Addendum #4

Date: 02/12/2024

Project: 2024 – Fishers Elementary School Addition & Renovations

PROJECT NO: 2021119 DATE: 02/12/2024 BY: Josh Cannaday

DRAWING NUMBER C401

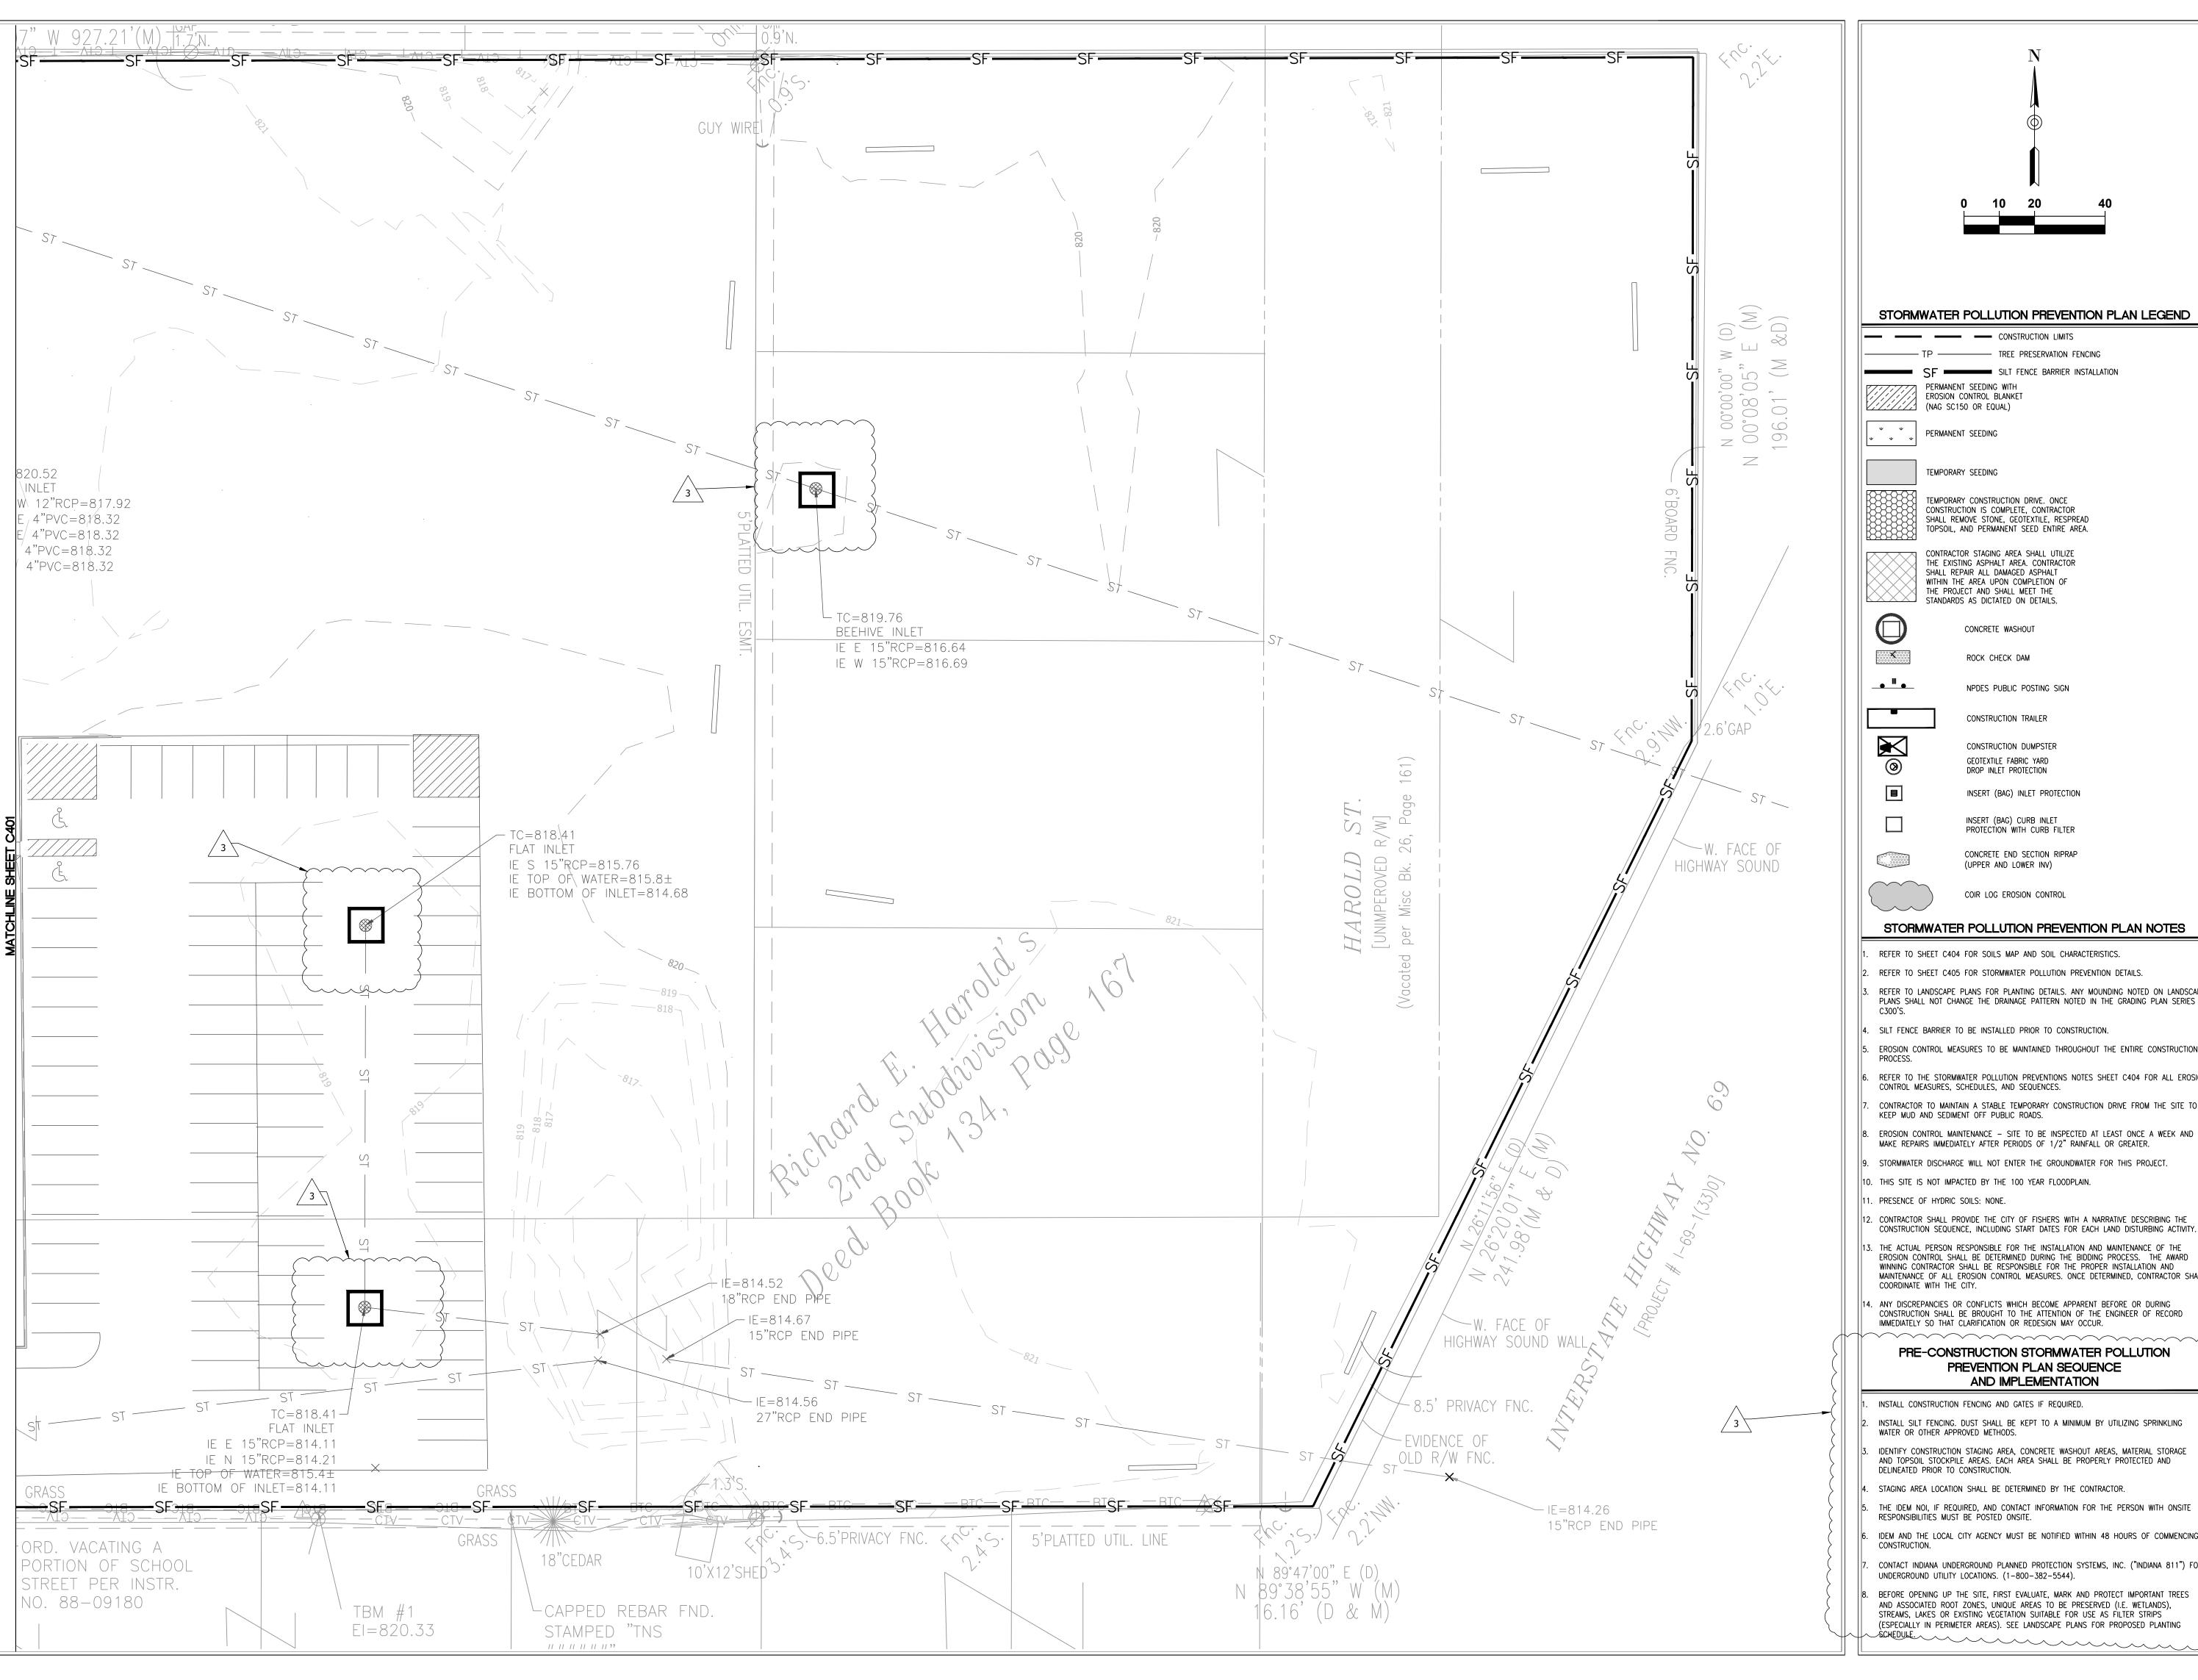
- B. Added grading information to "dig pit" at east end of playground
- C. Added spot grades along walk east of building.
- 4.7 C401
  - A. Revised/Updated Phased Erosion Control Plan per City requirements.

DRAWING NUMBER C402

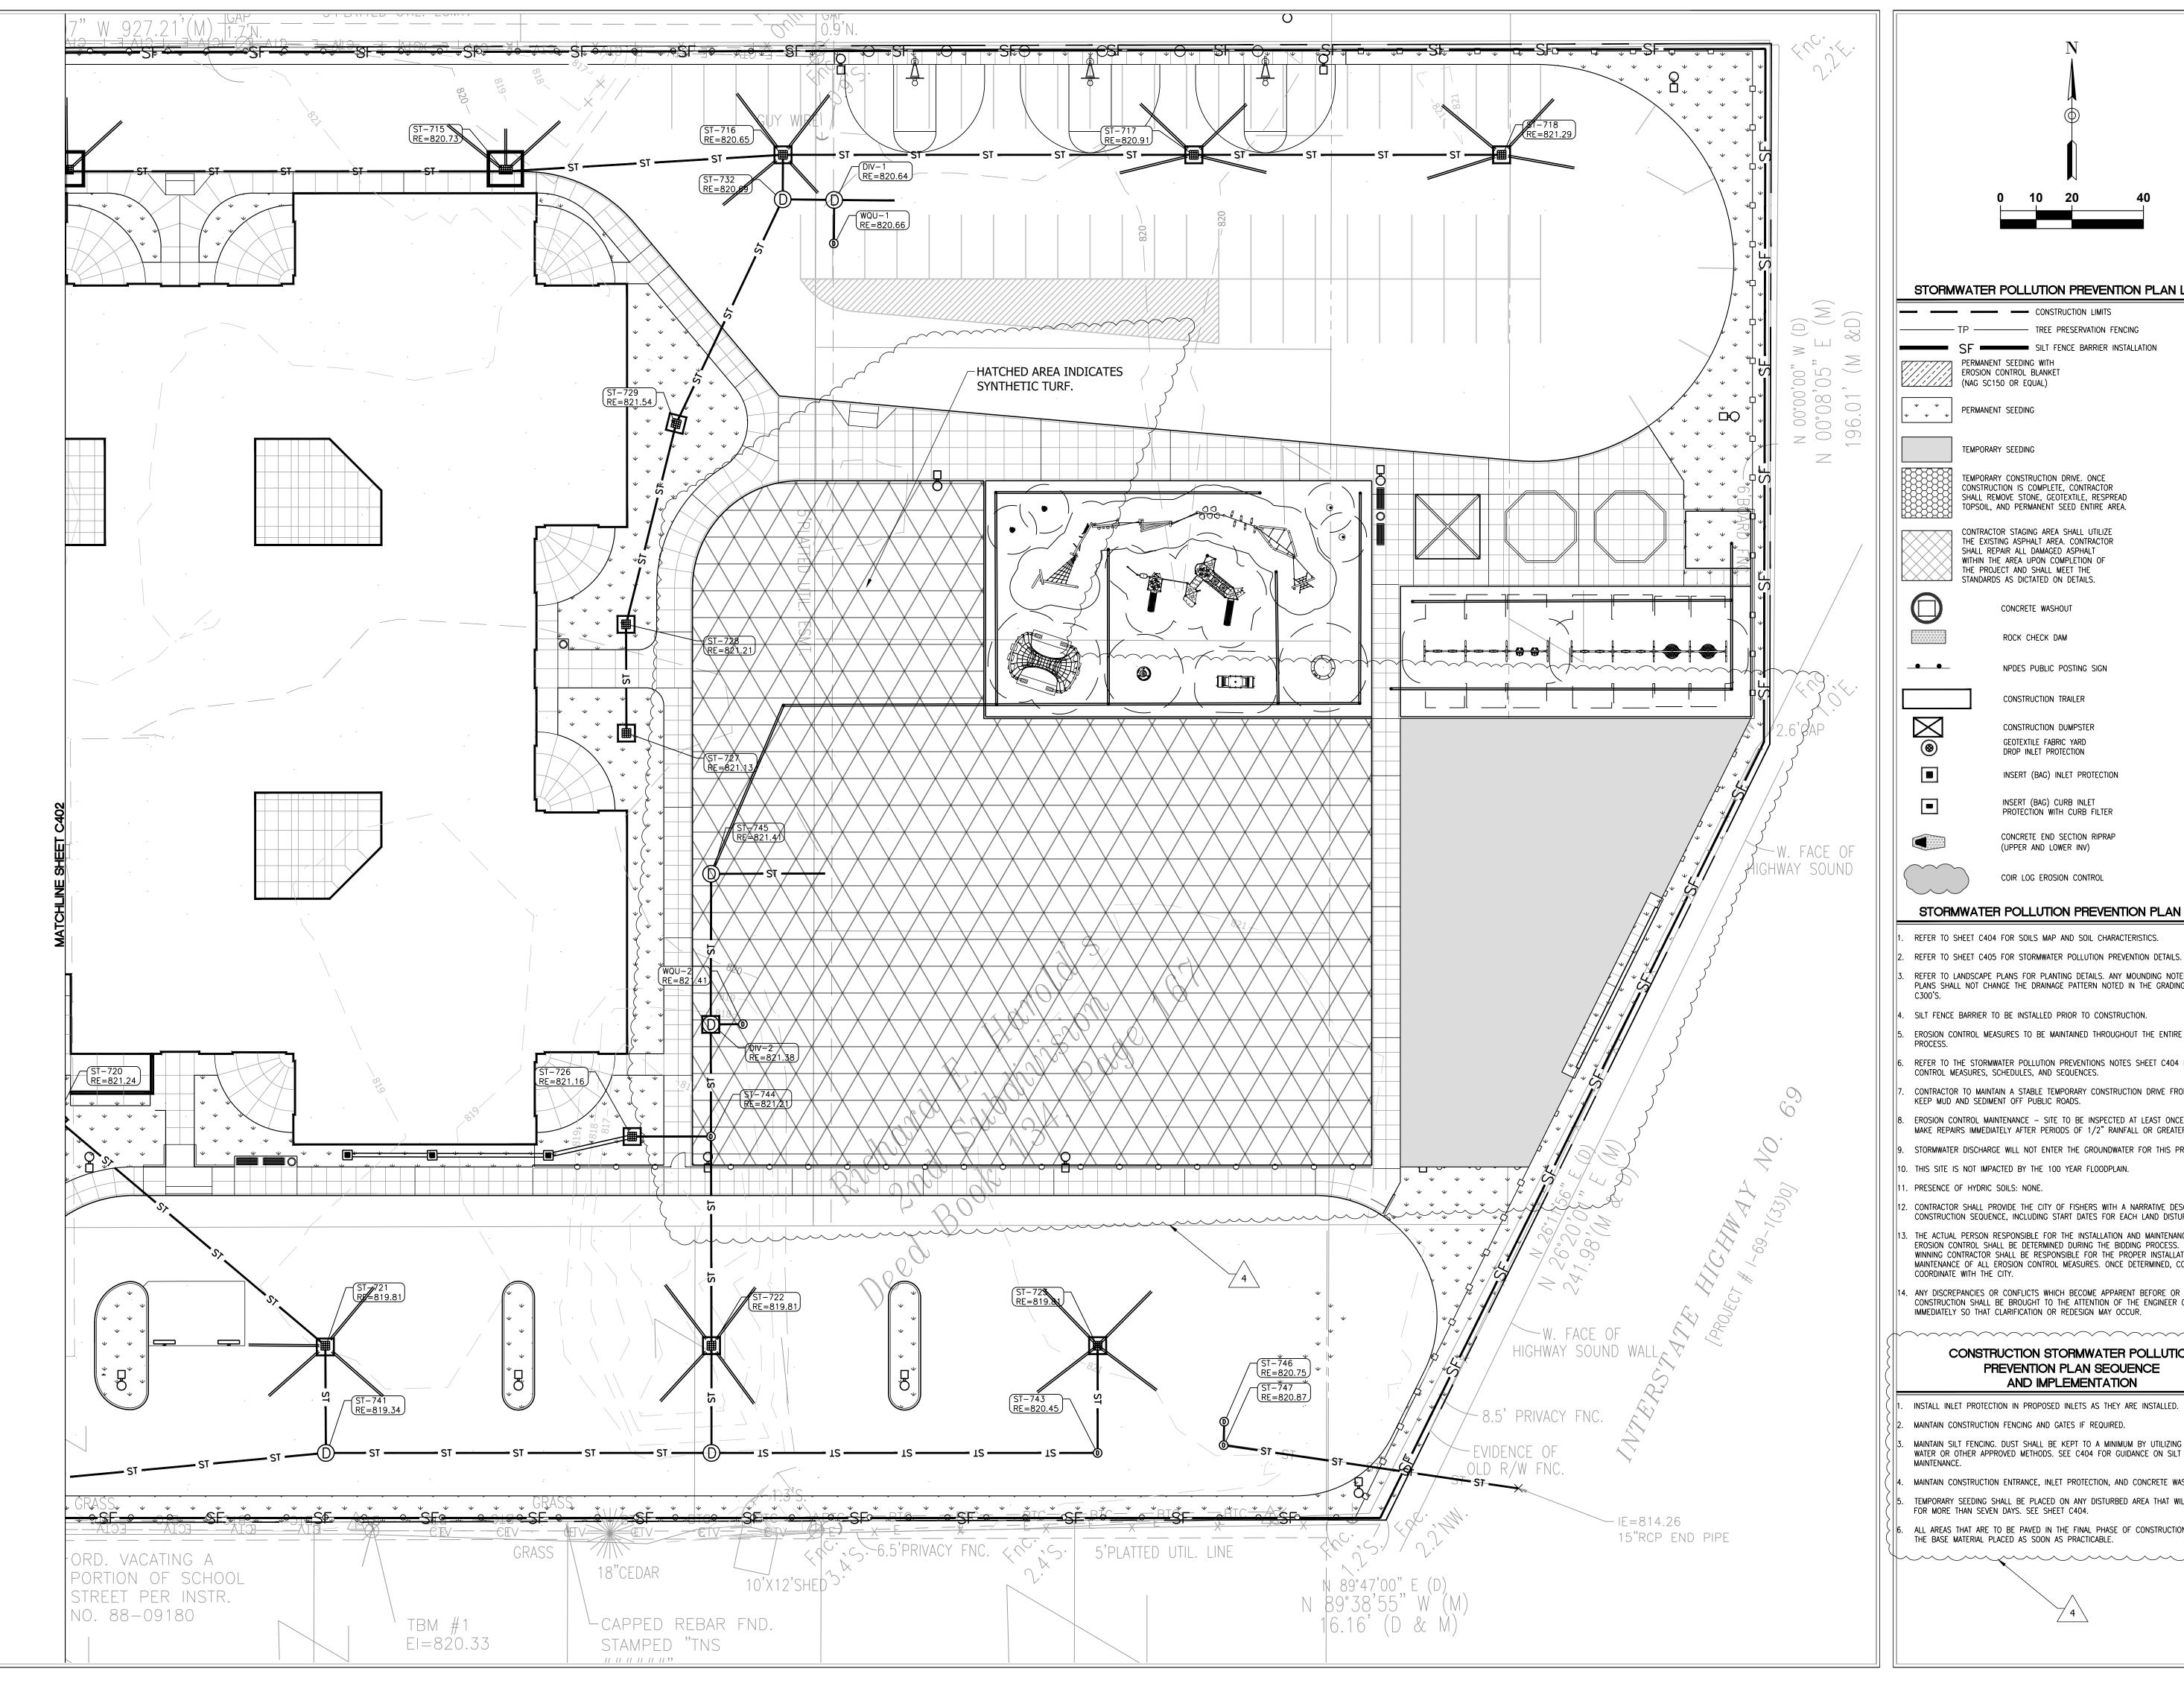
- 4.8 C401A
  - A. Revised/Updated Phased Erosion Control Plan per City requirements.
- 4.9 C402
  - A. Revised/Updated Phased Erosion Control Plan per City requirements.

> DRAWING NUMBER C403

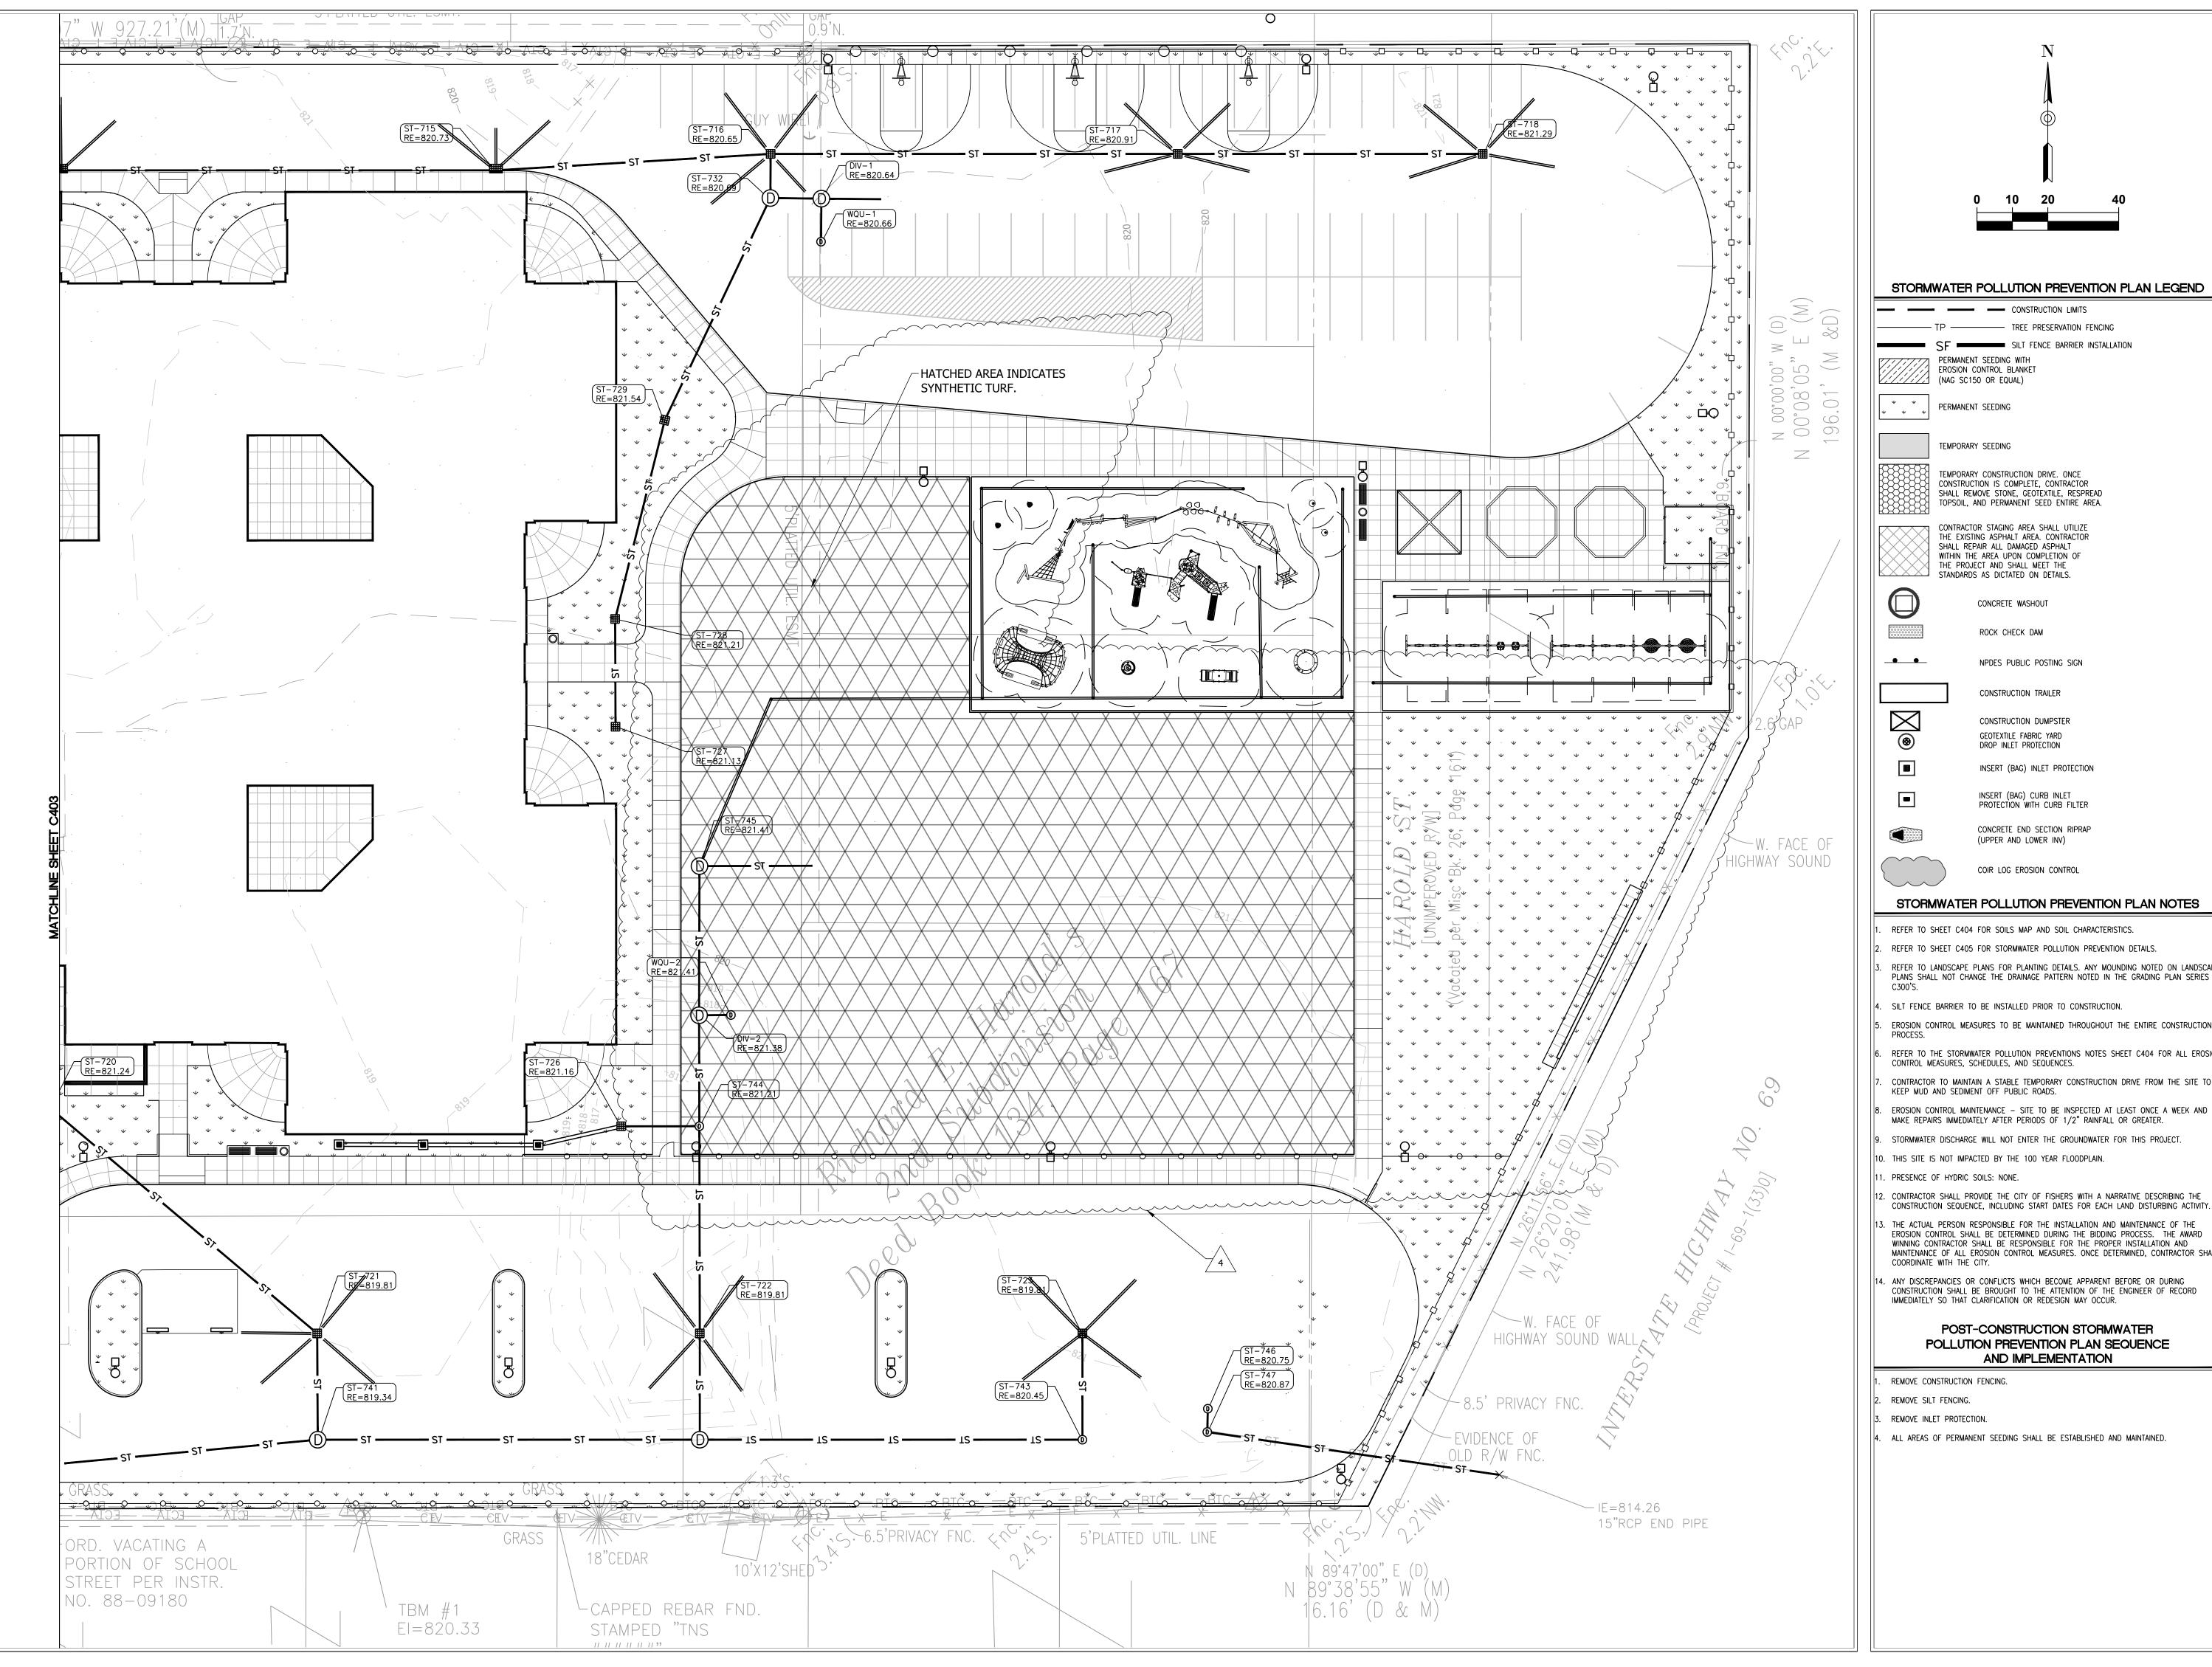
- 4.10 C402A
  - A. Revised/Updated Phased Erosion Control Plan per City requirements.
- 4.11 C403
  - A. Revised/Updated Phased Erosion Control Plan per City requirements.
